## **RADFORD ARMY AMMUNITION PLANT, VIRGINIA**

### **Work Plan Addendum 009: SWMU 31 and Horseshoe Area Groundwater Study**

Re: Radford Army Ammunition Plant  
SWMU 31 and the Horseshoe Area Groundwater Study  
Work Plan Addendum 9  
Document submittal and review

Response to EPA Comments on Master Work Plan (MWP) dated February 2002;  
Work Plan Addendum (WPA) 009, dated February 2002;  
And Work Plan Addendum (WPA) 012, dated February 2002  
Comments dated 22 May 2002  
From Rob Thomson

RADFORD AAP		FIGURE 1-10	
PREPARED BY: IT CORP.	TASK NO: 86622820000000	PROPOSED RIVER, SPRING, AND WELL GAUGING LOCATIONS	
CHECKED: MT	IT DWG NO:		
DATE: OCTOBER 2001	FIGURE 1-10

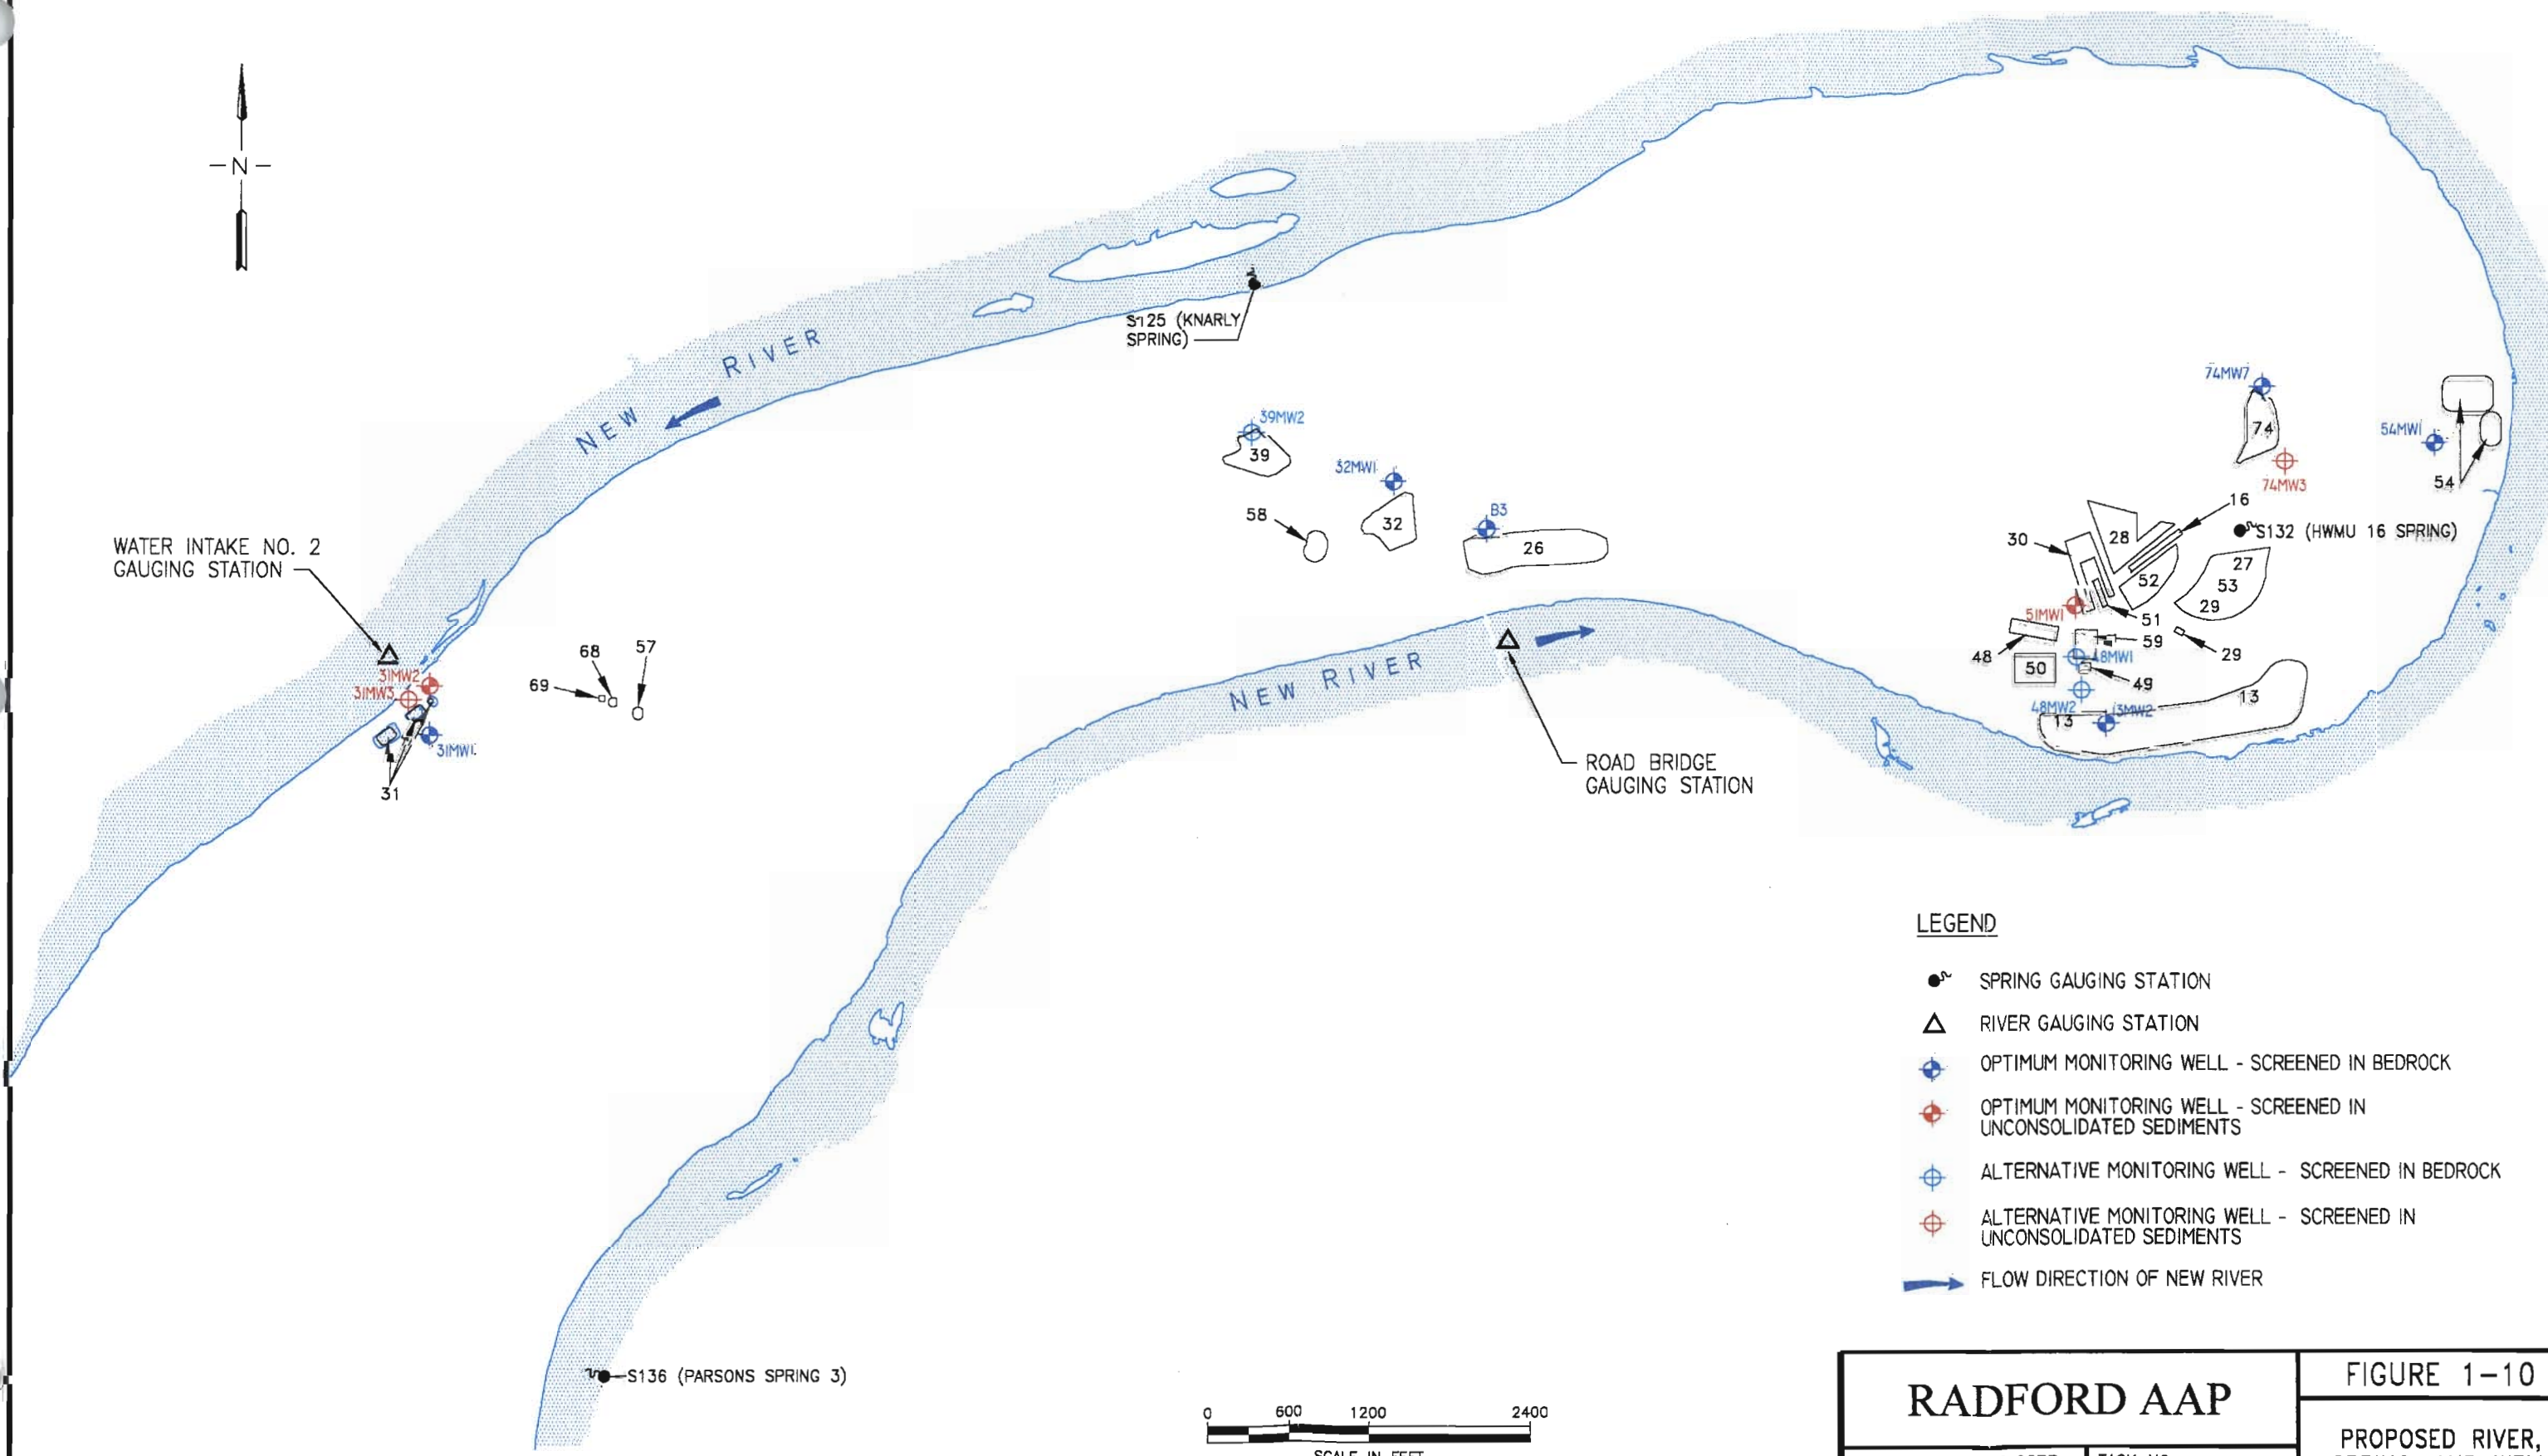
**Comment:** The fifth bullet under "*Bedrock monitoring wells*" states that "well locations are geographically spaced across the HSA." However, the wells selected as "optimum wells" (refer to Figure 1-10 and Table 1-15) are existing wells that were installed to study SWMU-specific groundwater conditions. No wells are, for example, proposed in the eastern half of the Horseshoe Area, except for the wells at SWMU 31. Revise the draft *Work Plan* to discuss how these wells will fulfill the objective of investigating groundwater on a "larger, regional scale instead of at individual sites" (Executive Summary, fourth sentence).
